## PLANNING COMMISSION RECOMMENDATION

SDP-9003-2021

**SUBJECT:** Final Staff Analysis  
Application SDP-9003-2021: 14 Firstfield Road

**SUBJECT:** SDP-9003-2021 - 604,929 square foot biotechnology campus at  
14 Firstfield Road

### CIRCULATION PATTERNS

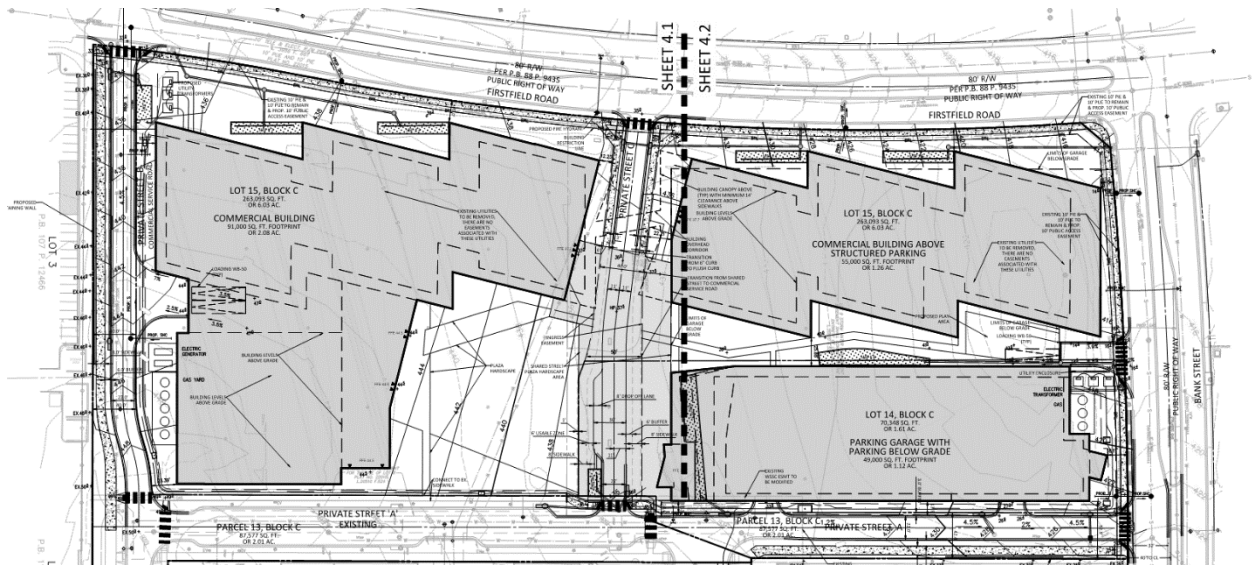
The Applicant has provided a response to comments related to the distance between Street A and the current curb cut for 1 Bank Street. According to the Applicant, Street A is approximately 50 feet from centerline to centerline from the 1 Bank Street curb cut. While the Applicant is of the opinion the design is adequate at this stage, the design will be further reviewed/refined as part of the final site plan and appropriate pavement marking and signage will be included to provide safety for all vehicles. As the Applicant mentions, this is a temporary condition and pursuant to the approved Sketch Plan, the final condition will re-align Street A with the existing curb cut/intersection into the adjacent

Truck deliveries will be accommodated via two loading areas located along street A and Bank Street. According to the Applicant, the locations of the loading docks were designed to keep loading off of Firstfield Road and Street C. The Applicant plans to implement a loading dock management plan to limit truck movement impacts on Bank Street and will be provided at Final Site Plan.

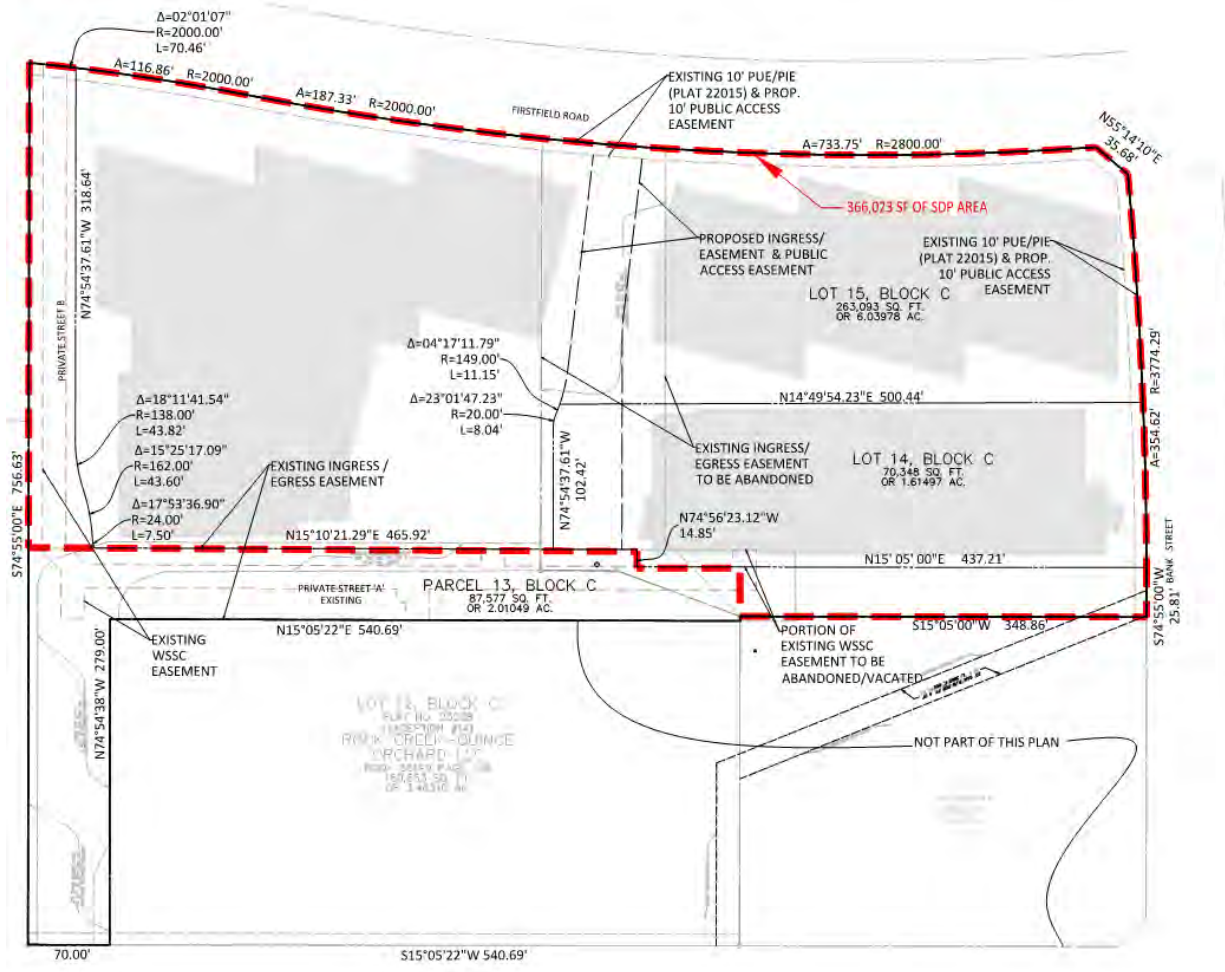
Since the joint public hearing, changes to the plan include the inclusion of retaining walls along Street A and B, revisions to the parking garage layout, and modifications to Street C to be in conformance with the City’s shard street typology.

Staff concurs with the Applicant’s response to comments raised during the Public Hearing. Staff finds that the preliminary wall details and locations of the retaining walls are sufficient for an SDP application and final details will provided and reviewed by Staff as part of the final site plan. A recommended condition of approval has been included that requires the Applicant to receive DPW approval of the final wall details as part of the final site plan submission.

In Staff’s opinion, the revisions to the street plans is sufficient and that no road code waivers are required. Refinements to Street C with the bollard details and any additional changes will be reviewed during the time of final site plan.

### Off-Street Parking

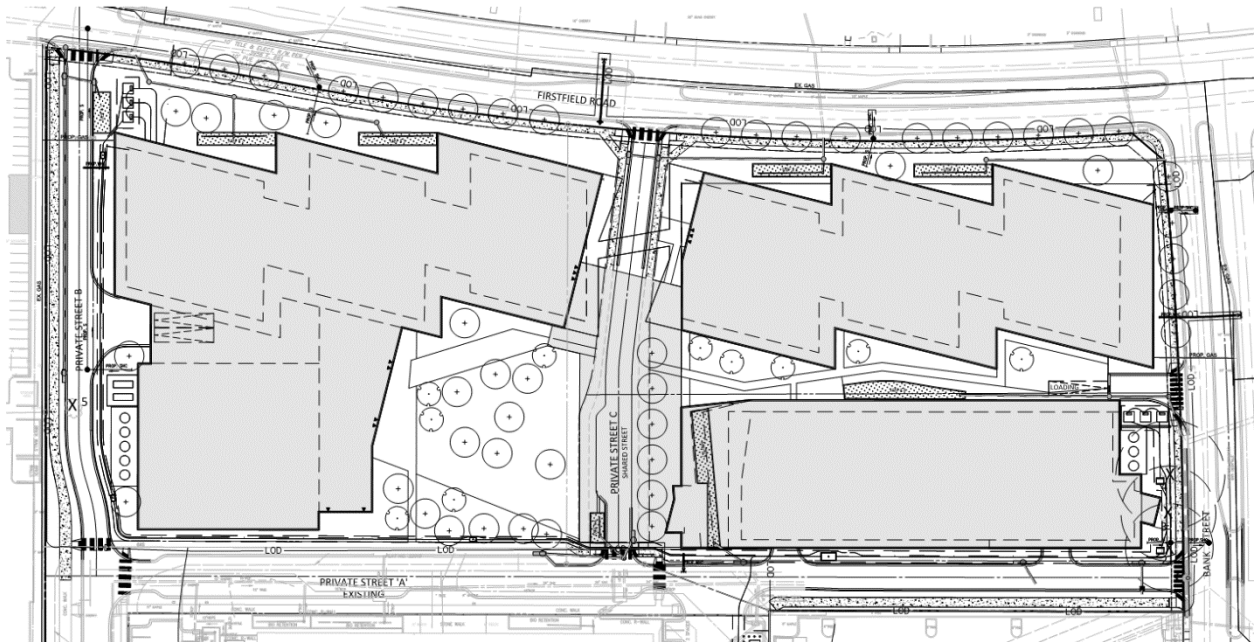
As part of the proposed project, the Applicant seeks approval to adjust the parking ratio for the Subject Property. Instead of the typical 1 space per 300 square feet of gross floor area, the applicant is requesting approval to park the project at 1 space per 650 square feet of gross floor area. The Applicant has provided a response to questions related to the adjusted parking ratio, which states the ratio is based on a projected employee count of 1,000 employees. While this is subject to change, the letter addresses how one-third of the employees will work on-site full time, another third of employees will have a hybrid schedule that includes remote and on-site work, and the final third will primarily work remotely.

Under the amended parking ratio the 604,929 square foot campus will require a minimum of 931 parking spaces. The subject site is also required to provide 225 parking spaces for the building at 700 Quince Orchard employment and therefore the minimum parking requirement for the site is 1,156 parking spaces. The application currently includes a total of 1,156 parking spaces.

Staff supports the proposed parking ratio and is of the opinion that the justification for the parking ratio is adequately supported by the information provided by the Applicant. The Applicant anticipates that one third of the projected 1,000 employees, which is approximately 333 employees, will work remotely while another 333 employees will be on a hybrid schedule. Assuming that every employee who worked on-site full time and those who were on a hybrid schedule had to show up to the Novavax Campus on the same day, then there would be a parking surplus.
